ADDENDUM NO. 2

October 27, 2022

Carey Ridge Elementary Addition & Renovation
16231 Carey Road
Westfield, IN 46074

Item No. 5 Sheet E001 – EXTERIOR LIGHTING PLAN

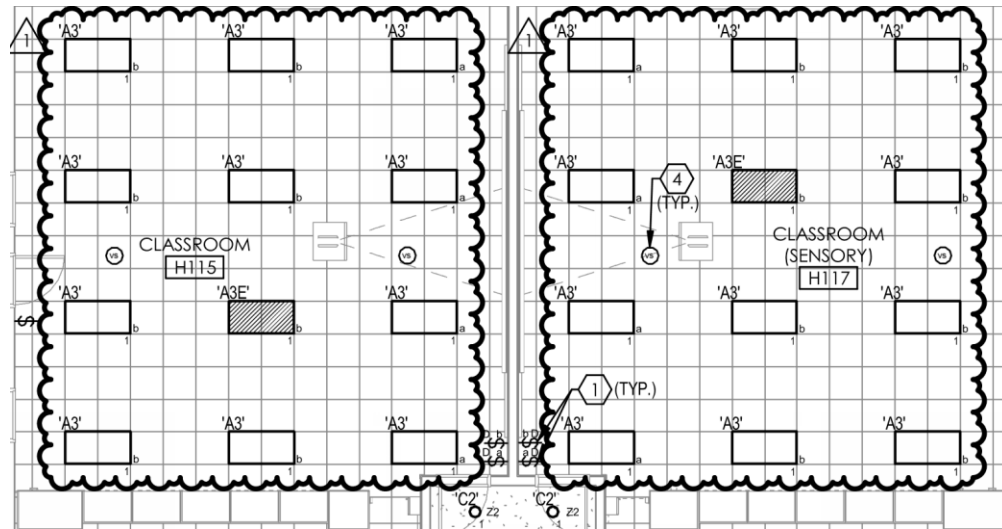
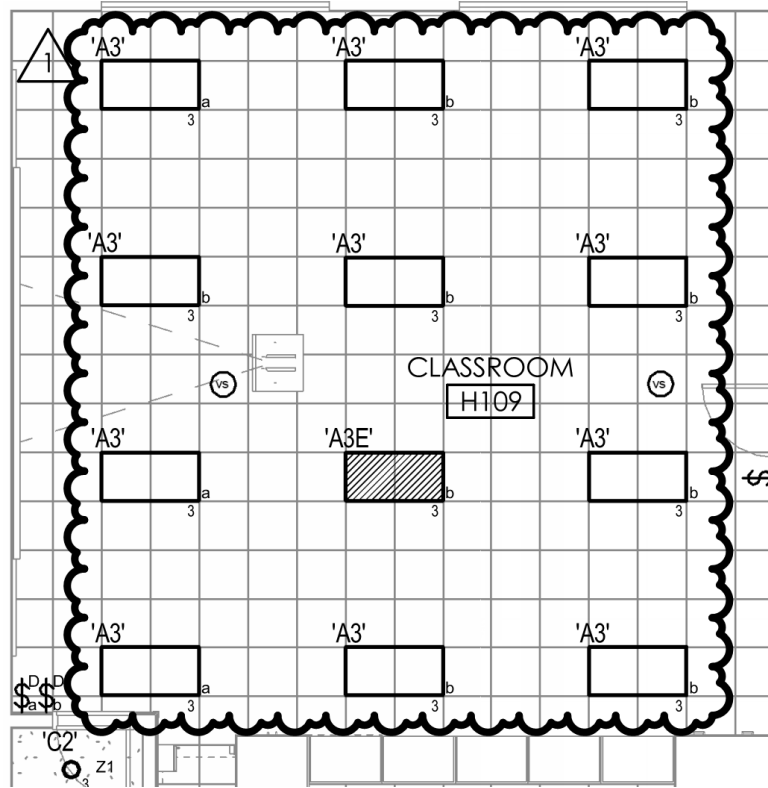
- B. Modified keyed note 1 to match pole type in light fixture schedule.

PROVIDE SITE LIGHT WITH CONCRETE BASE. PROVIDE WIRE AND CONDUIT FROM EXISTING LIGHTING POLE CIRCUIT THAT MATCHES EXISTING SIZE. MATCH EXISTING LIGHTING POLE CONSTRUCTION (ASSUMED TO BE 30', ANODIZED BRONZE, ROUND TAPERED. FIELD VERIFY.). REFER TO SHEET E501 FOR DETAIL.

Item No. 6 Sheet E101 – PARTIAL LIGHTING PLAN – UNIT 'H'

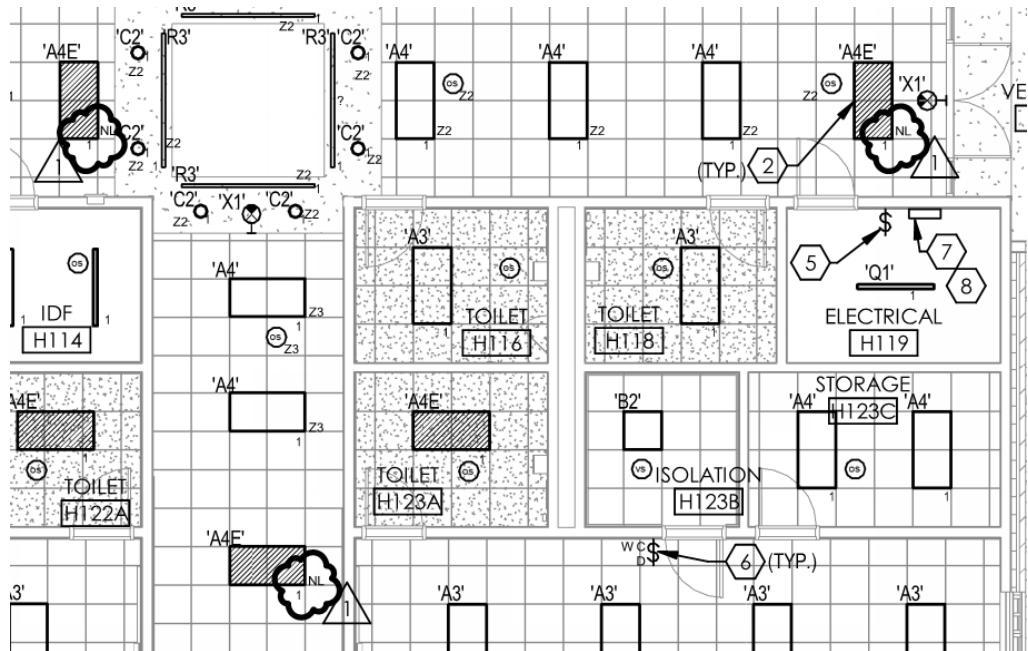
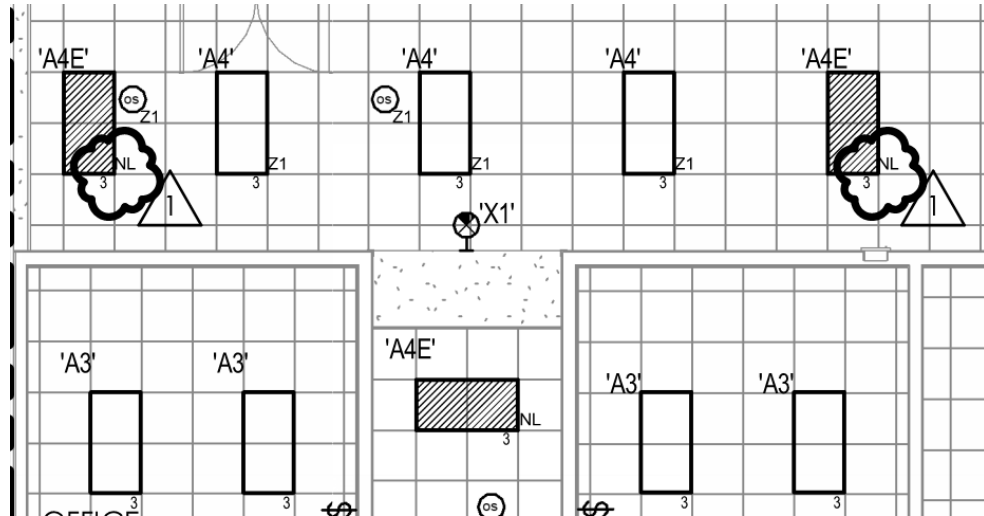
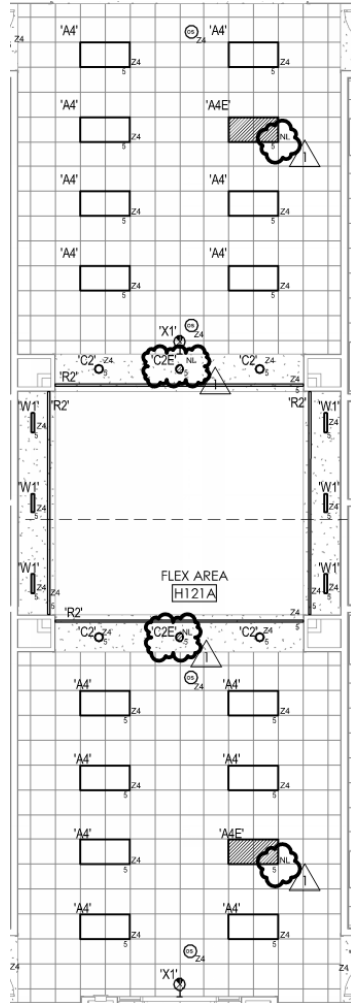
- A. Rotated lights in H109, H115, and H117.

B. Indicated light light fixtures in corridors.

C. Modified lighting layout in Storage H123 to match Storage H122C.

Item No. 7 Sheet E201 – PARTIAL POWER PLAN – UNIT 'H'

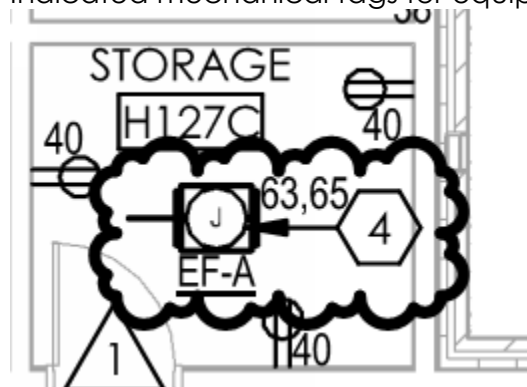
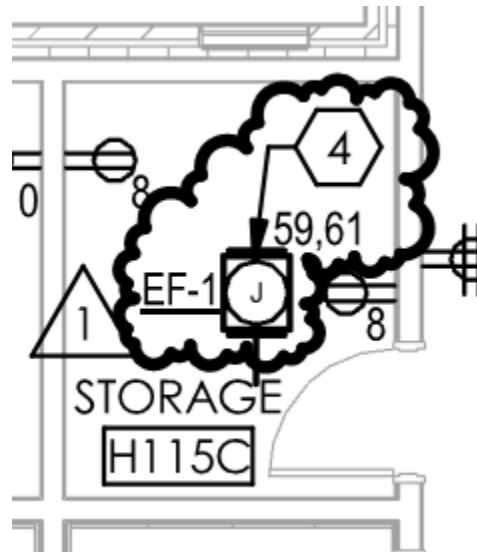
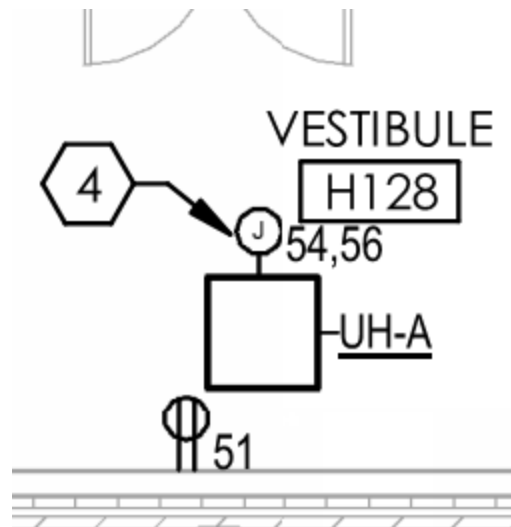
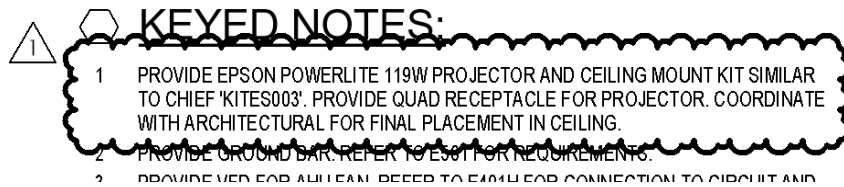
A. Indicated mechanical tags for equipment.

B. Modified keyed note 1.

Item No. 8 Sheet E301 – PARTIAL SIGNAL PLAN – UNIT 'H'

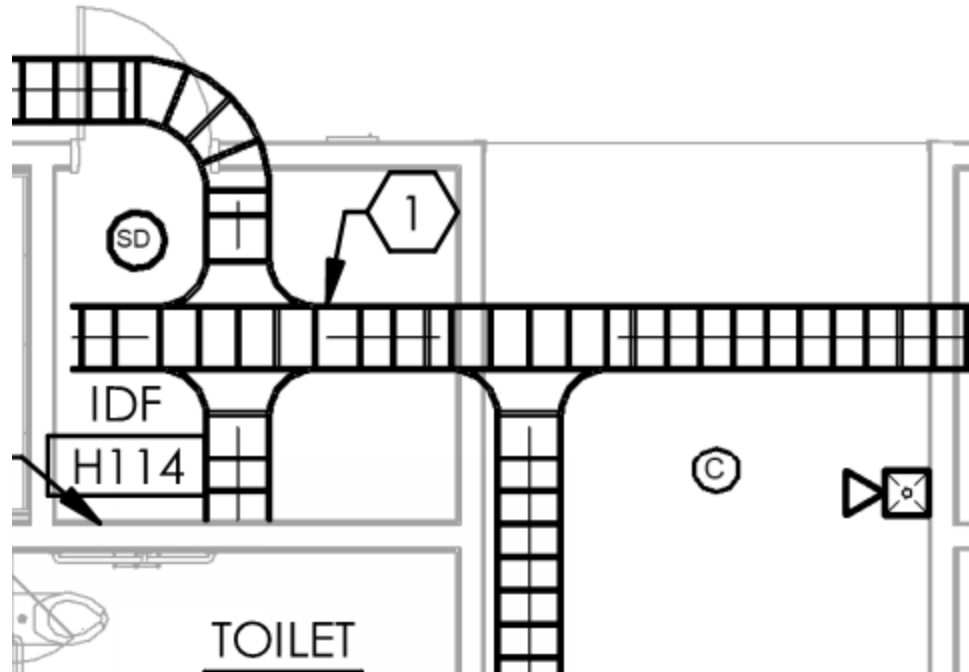
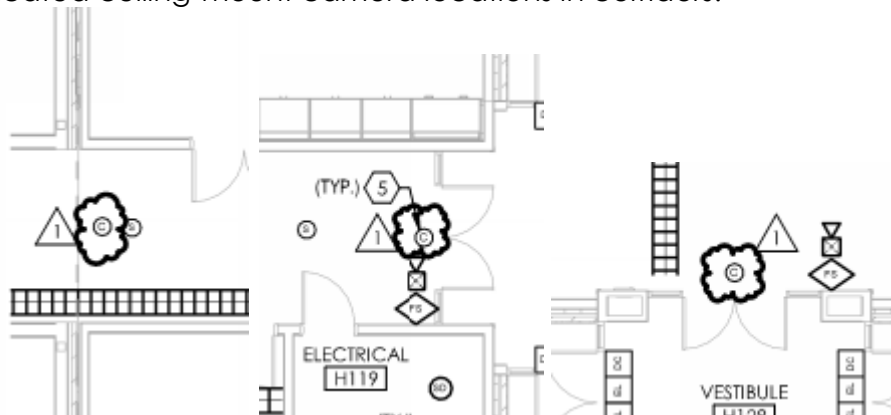
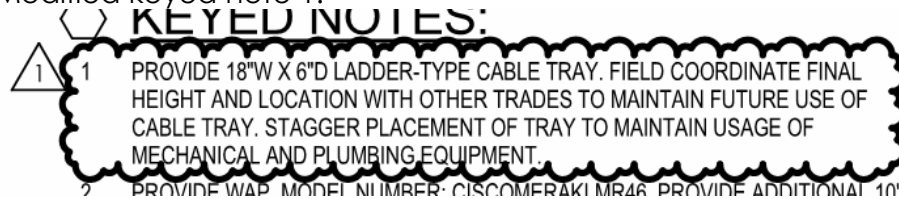
- A. Removed extra leader for keyed note 1.
- B. Moved ceiling camera to correct location.

C. Indicated ceiling-mount camera locations in corridors.

D. Modified keyed note 1.

Item No. 9 Sheet E401F – PARTIAL POWER PLAN MECHANICAL ROOM UNIT 'F'

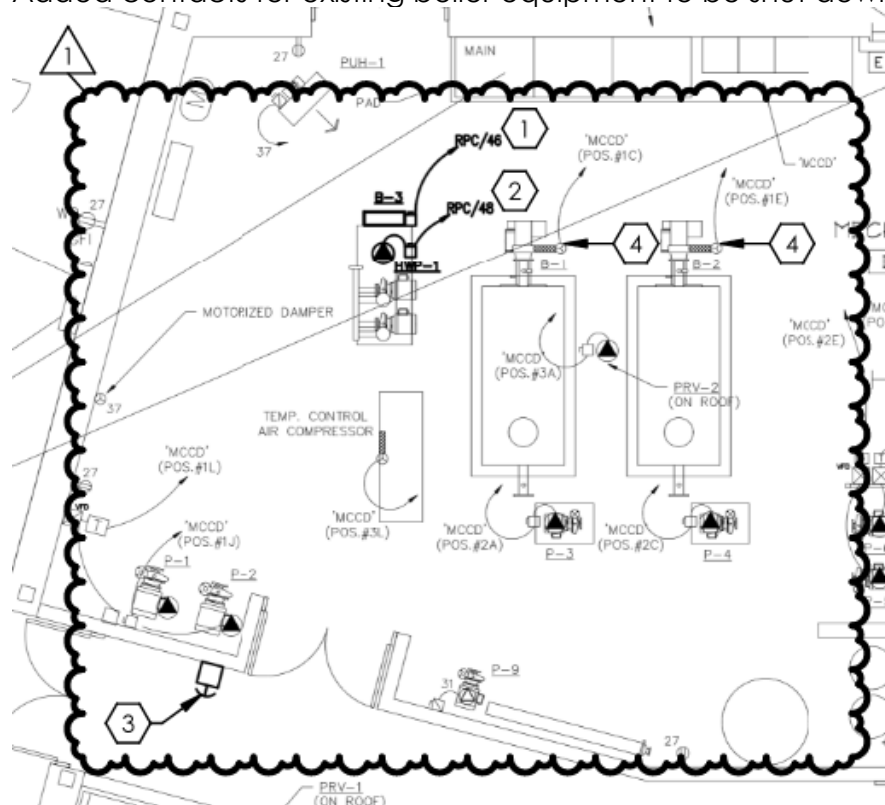
- A. Modified keyed note 1.
- B. Added keyed notes 2, 3, and 4.

- C. Added disconnects for boiler equipment.
 D. Added emergency stop shutdown button.
 E. Added contacts for existing boiler equipment to be shut down.

- 1 PROVIDE (2) #12 & (1) #12 GND IN 3/4" C FOR BOILER EQUIPMENT. PROVIDE 120V, 30A, 1P, NEMA 1 DISCONNECT WITH AUXILIARY CONTACTS FOR REMOTE EMERGENCY SHUTDOWN. COORDINATE FURTHER REQUIREMENTS WITH MECHANICAL.
- 2 PROVIDE (2) #12 & (1) #12 GND IN 3/4" C FOR BOILER EQUIPMENT. PROVIDE 120V, 30A, 1P, NEMA 1 DISCONNECT. COORDINATE FURTHER REQUIREMENTS WITH MECHANICAL.
- 3 PROVIDE 3P, CONTROL-VOLTAGE, E-STOP PUSHBUTTON FOR BOILERS AT 42" A.F.F. PUSHBUTTON SHALL SHUT DOWN ALL BOILERS AT ONCE. PROVIDE CONTROL-VOLTAGE CABLING TO CONTACTS IN BOILER DEVICES FOR SHUTDOWN FUNCTIONALITY. PROVIDE WITH CLEAR, PLASTIC COVER.
- 4 PROVIDE CONTROL-VOLTAGE DRY CONTACT IN EXISTING BRANCH CIRCUIT FOR REMOTE EMERGENCY SHUTDOWN. COORDINATE WITH BOILER VENDOR FOR BEST LOCATION. MODIFY BRANCH CIRCUIT AND/OR MCC BUCKET AS NECESSARY.

Item No. 10 Sheet E601 – ELECTRICAL SCHEDULES

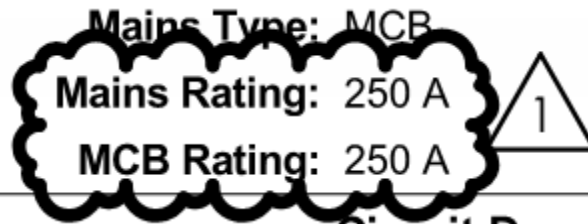
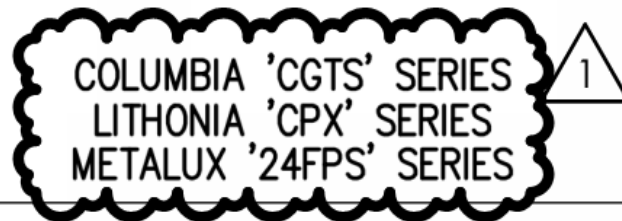
- A. Indicated a 250A MCB for 'RPJ'.

- B. Modified light fixture types as indicated above from contractor question No. 2.

Item No. 12 Sheet E701 – ELECTRICAL ONE-LINE DIAGRAM

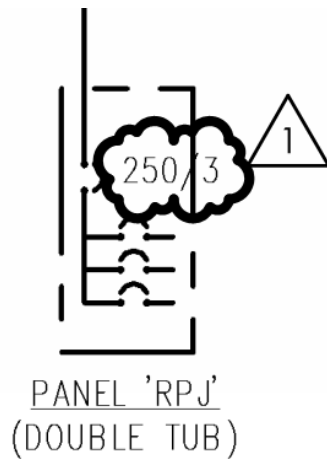
- A. Indicated a 250A MCB for 'RPJ'.

DRAWING NUMBER
AD203D

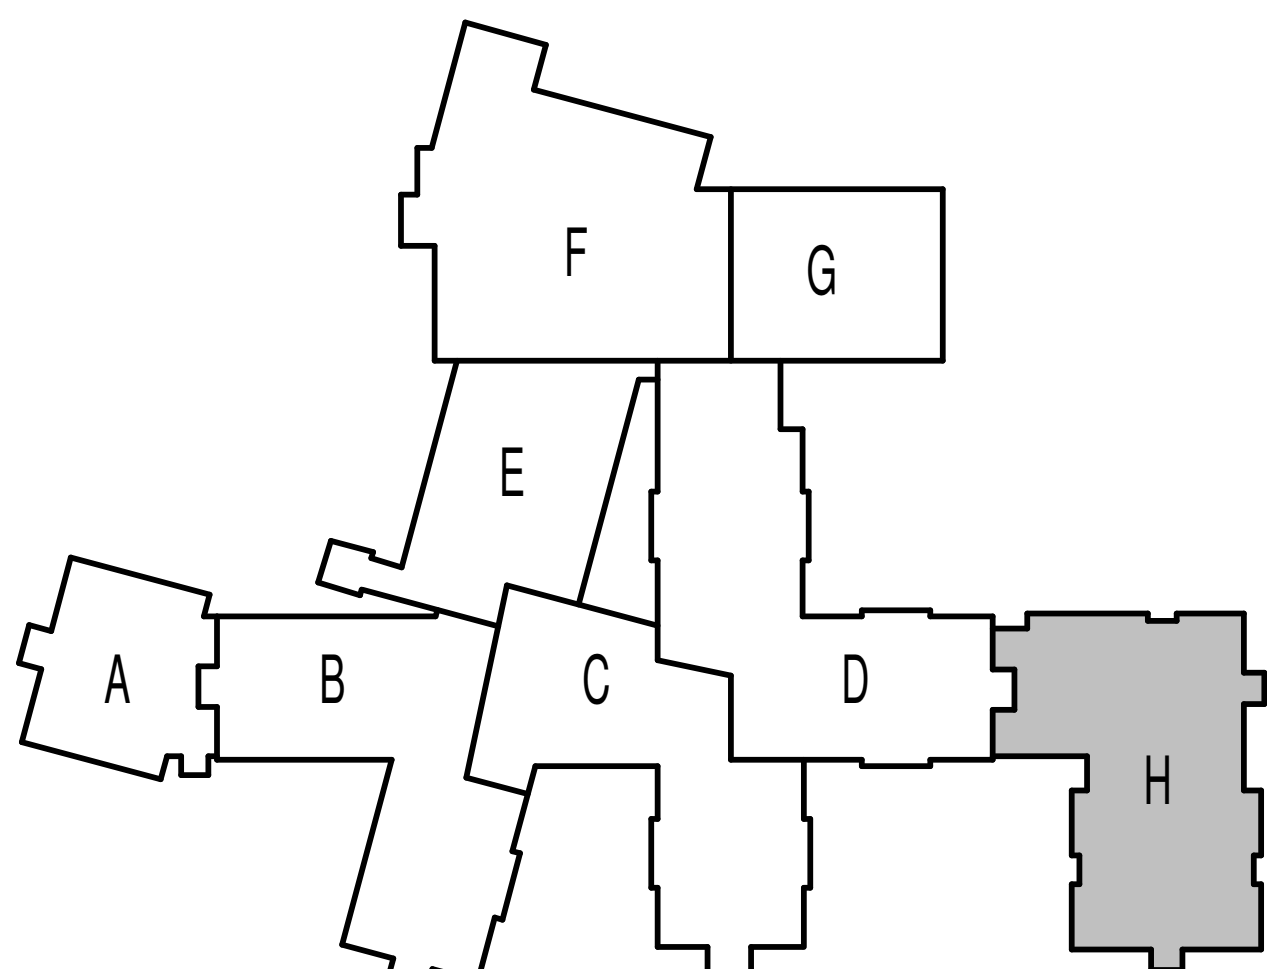
- A. Add Keyed Demolition Notes #25, #26 AND #27.
- B. Revised Keyed Demolition Note #24.

1
A210
REFLECTED CEILING PLAN - UNIT H
SCALE: 1/8" = 1'-0"

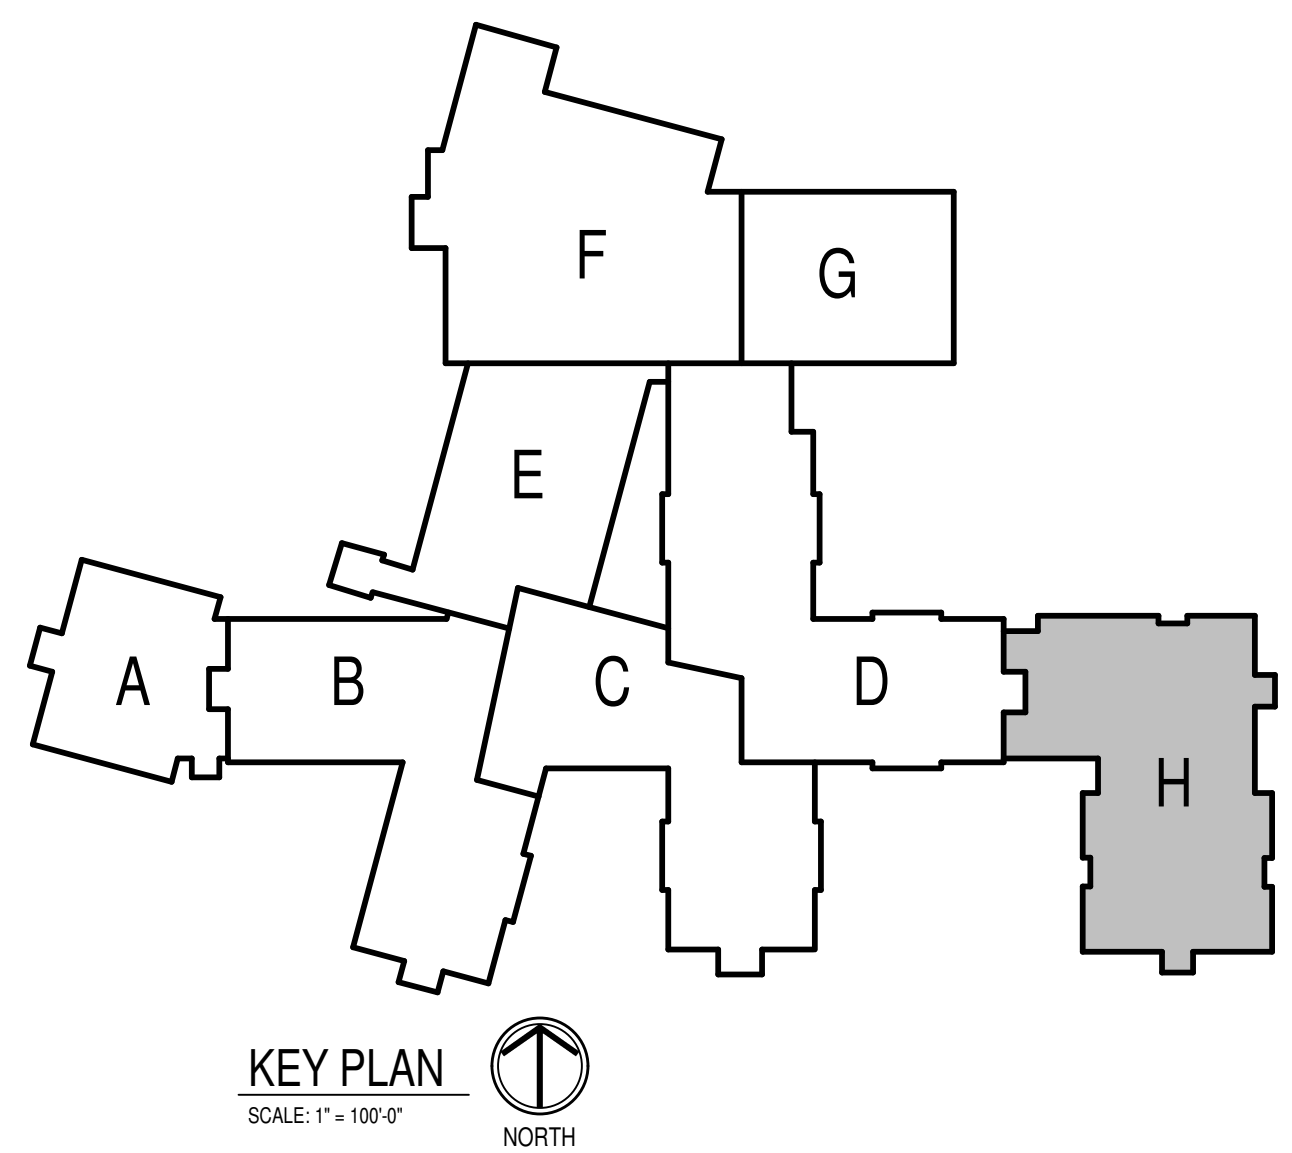
- A. Add Section Detail Tag 7/A431 to reflected ceiling plan to note soffit expansion joint.
